Product Discontinuation Notices

Issue Date
April 26, 2024

Limit switch

D4C-□4□□ some series
D4C-□5□□ some series
D4C-1933

Product discontinuation Model D4C-1541	Product discontinuation Model D4C-1342

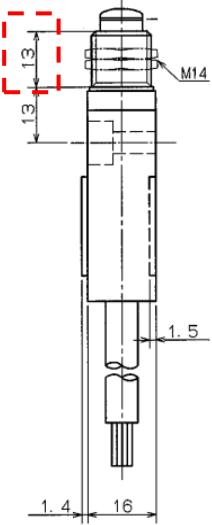
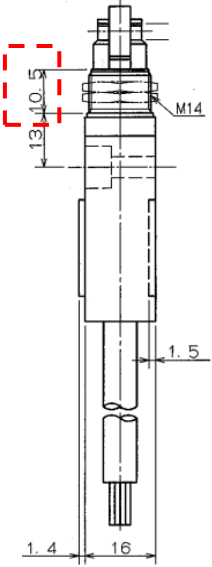
- The color of the ground wire is different.
- In addition to changing the operating position, the shape of the actuator changes. Please note. Please adjust so that the actuator returns to the free position when it is not pushed in. Please note that depending on the application, it may be necessary to adjust the mounting position and also change the shape of the dog.

Item	Product discontinuation Model D4C-1541	Product discontinuation Model D4C-1342
<p>Operating position</p>	<p>31.2±1mm</p>	<p>36.8±1mm</p>
